DEVIATION REQUEST AND DECISION FORM

PROJECT INFORMATION – NEW LOG ROAD DEVIATION REQUEST

Project Name : Mayberry, Colorado Springs Filing No. 1
 Schedule No.(s) : 34000-00-259, -260, -349, -350, -356, -362
 Legal Description : Mayberry, Colorado Springs Filing No. 1

SHEET: **PP1**

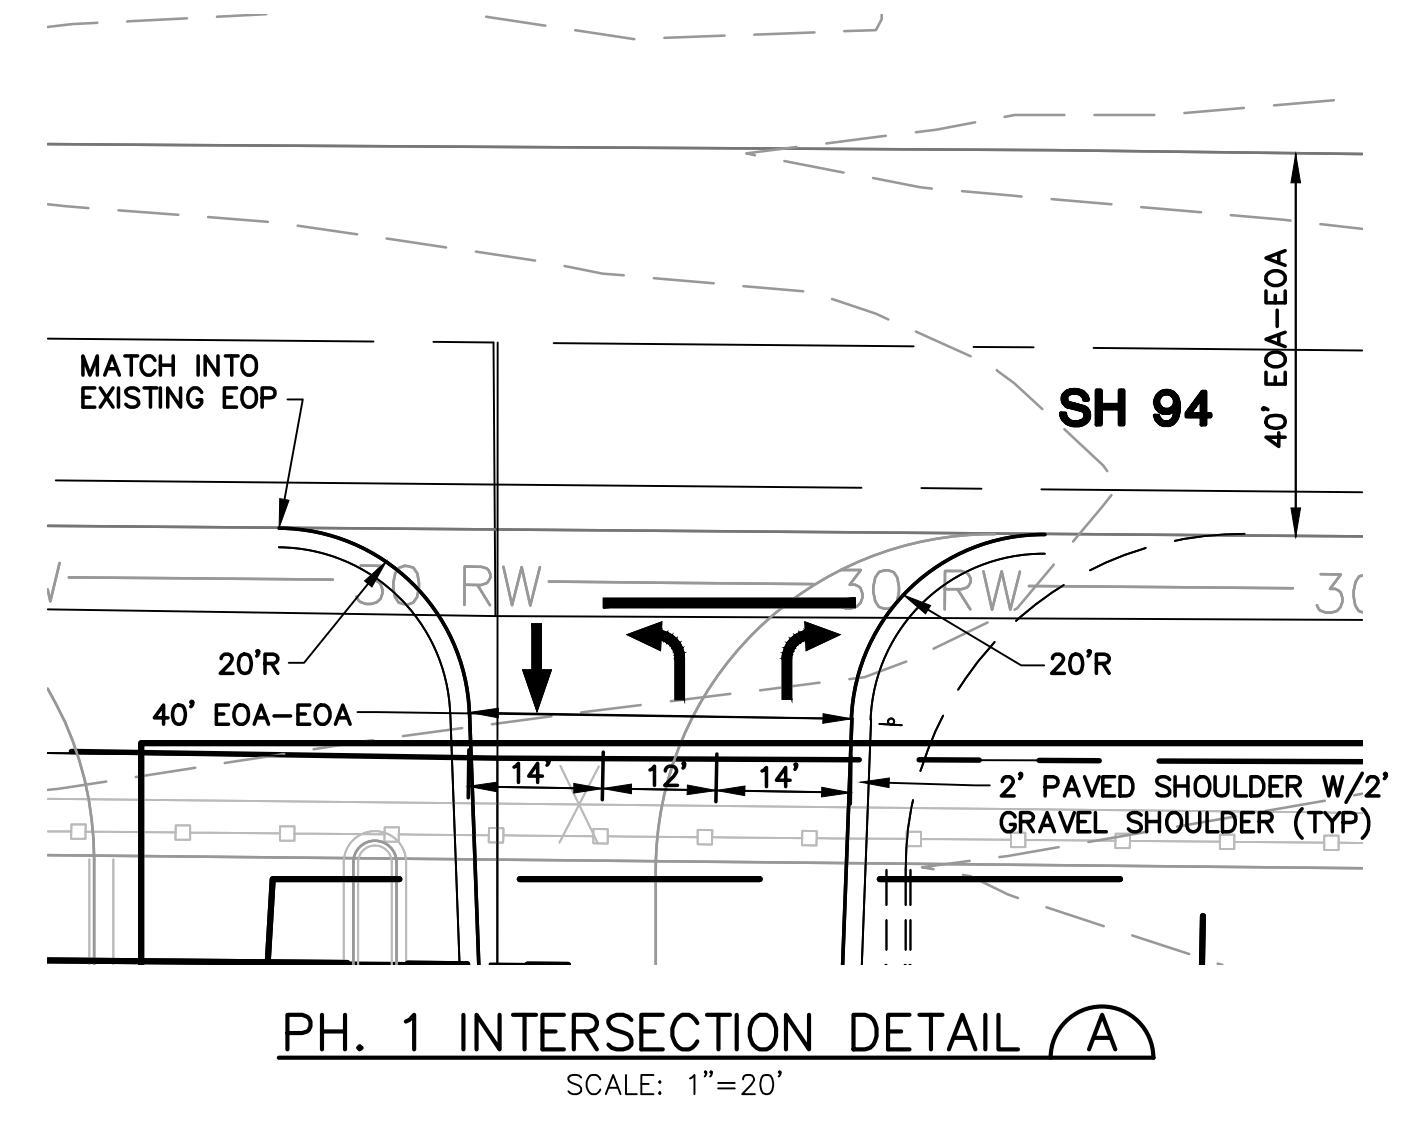
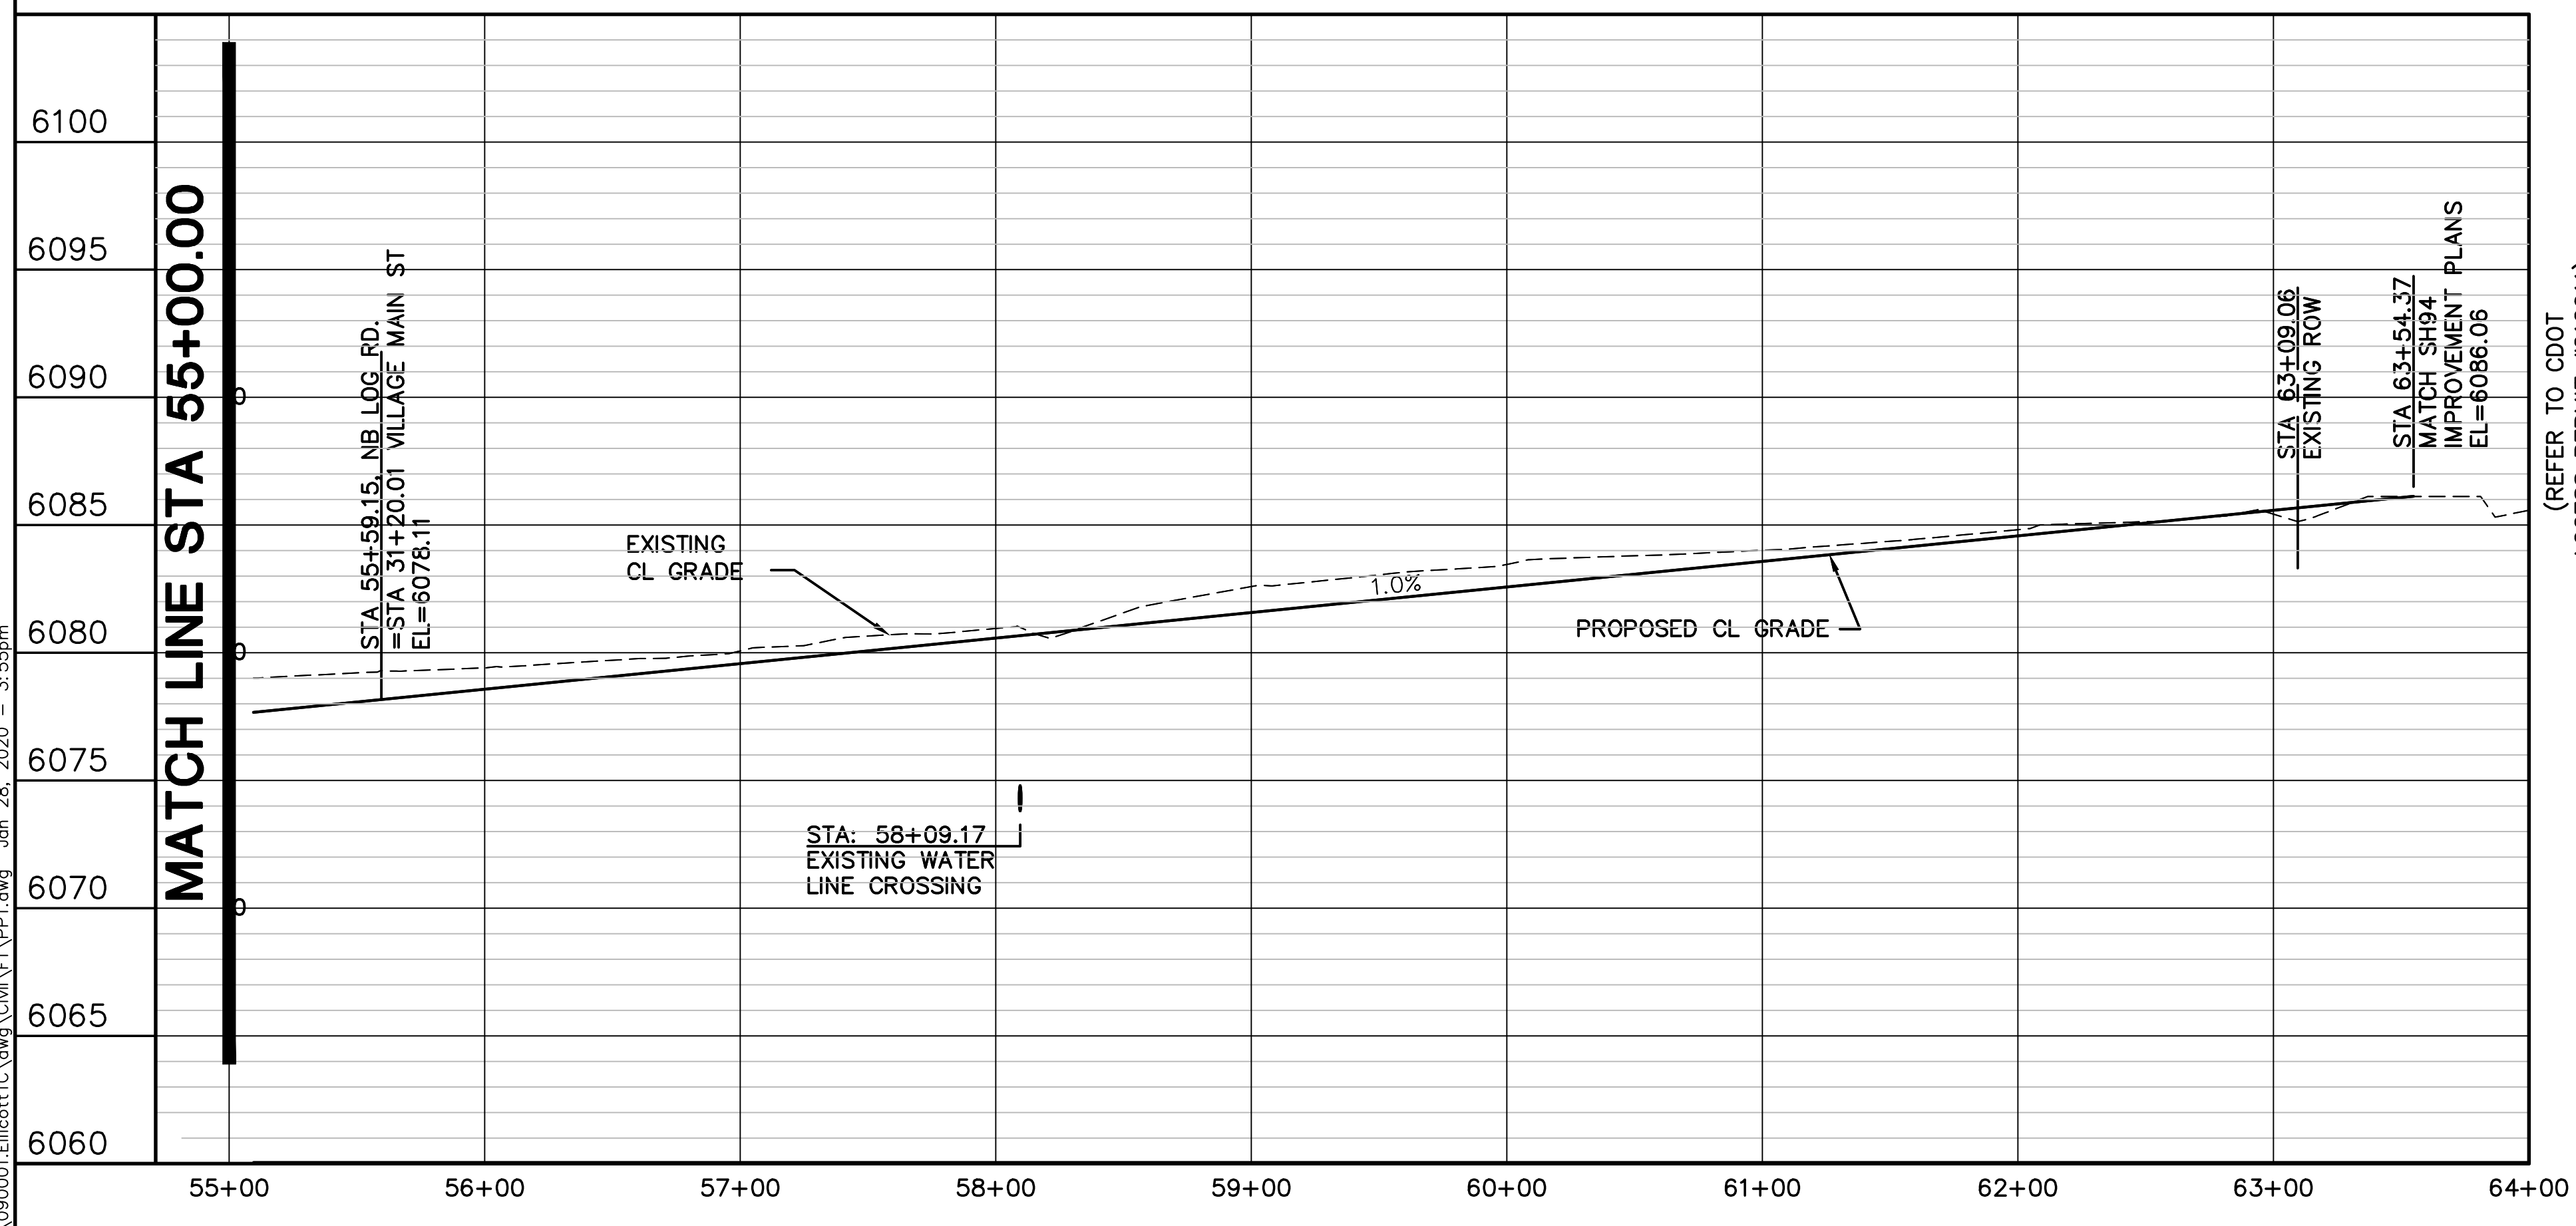
The ECM-prescribed minimum horizontal centerline radius for an urban minor arterial is 565 feet. This deviation request also allows for a slightly reduced minimum centerline radius of 527 feet at couplet transitions as depicted on the attached Plan & Profile Drawing (Sh. PP1).

The proposed minimum centerline radius of 527 feet is only a slight reduction compared to the standard minimum radius of 565 feet.

RURAL RESIDENTIAL TYPICAL SECTION (F)

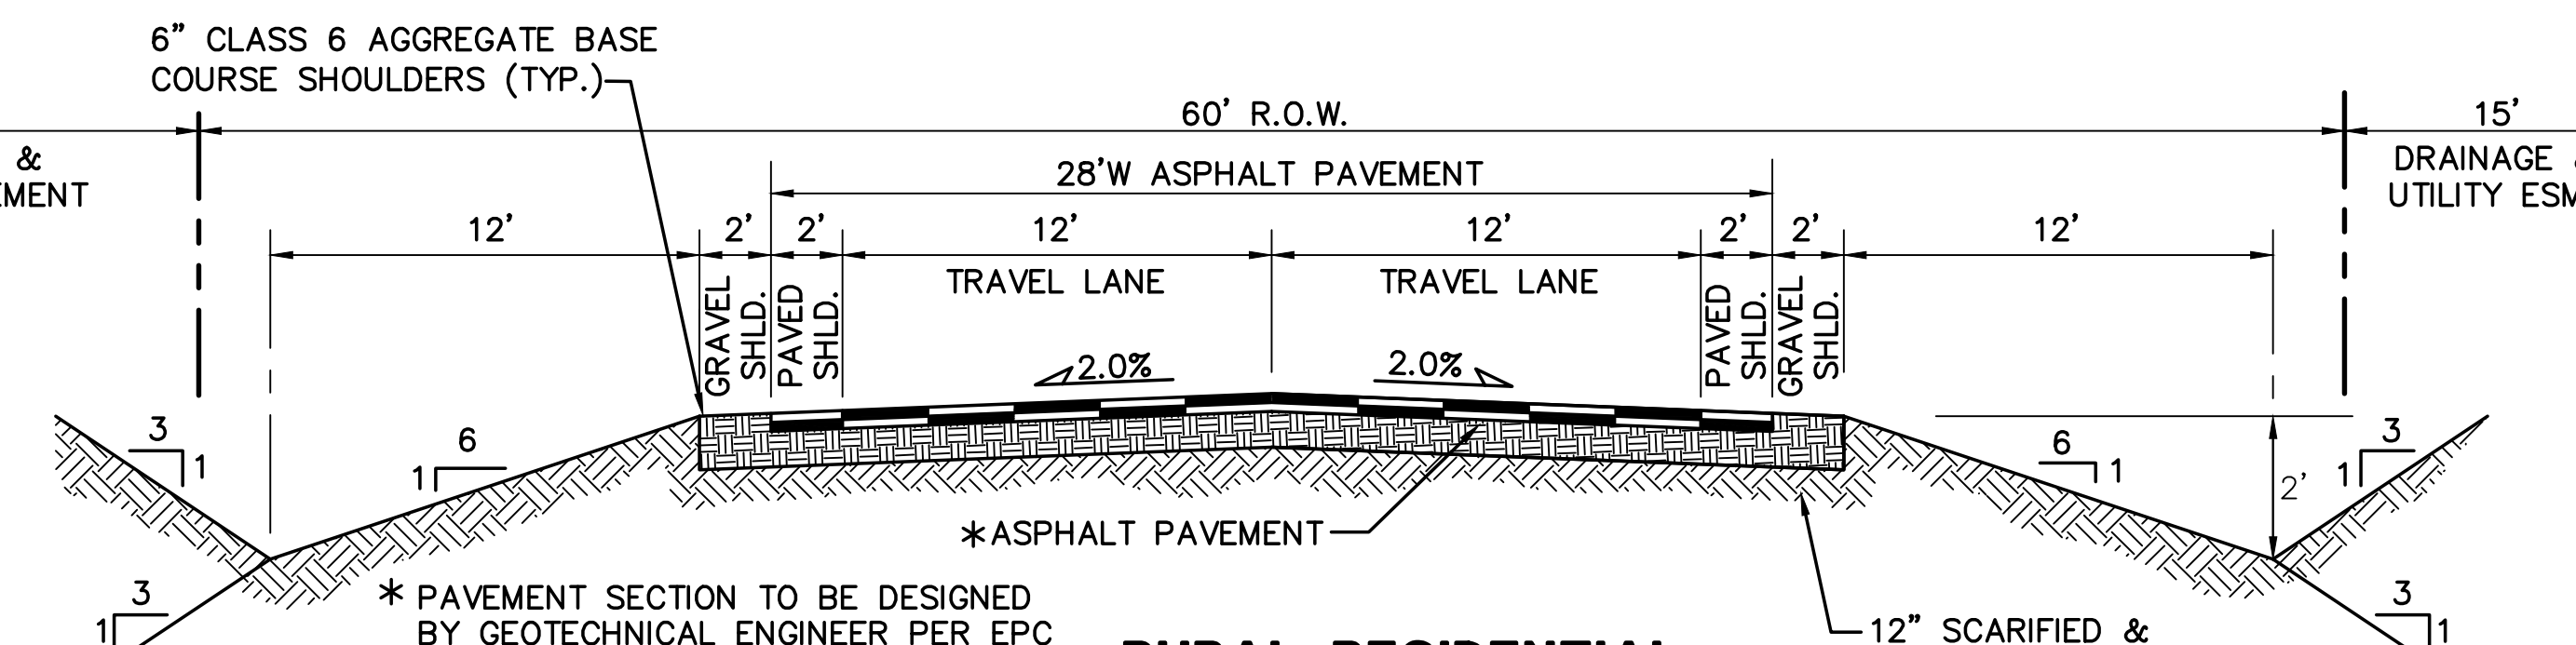
The interim road cross section consists of a 2-lane rural residential road section during Filing No. 1. The interim rural road section depicted on Section F, Sheet TY1 conforms to County standards for rural local roads.

TYPICAL URBAN ARTERIAL ROAD SECTION (A)
(ULTIMATE LOG ROAD AT COUPLER)
SCALE: 1"=5' H
1"=2.5' V

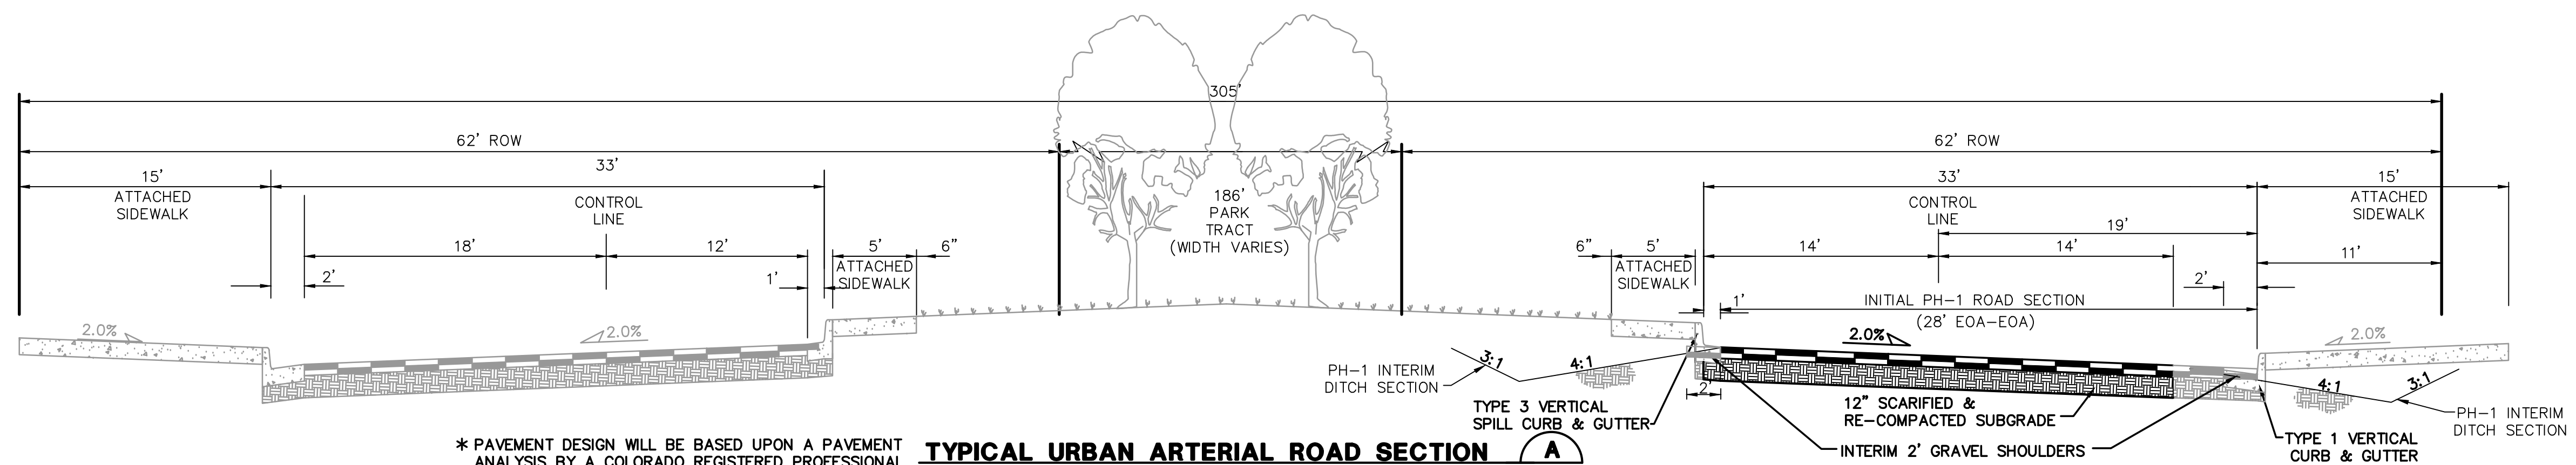
The ultimate road section of New Log Road consists of a 2-lane, 1-way Couplet through the Town Center area in accordance with the approved Ellicott Town Center PUD, as depicted in Section A, Sheet TY2.
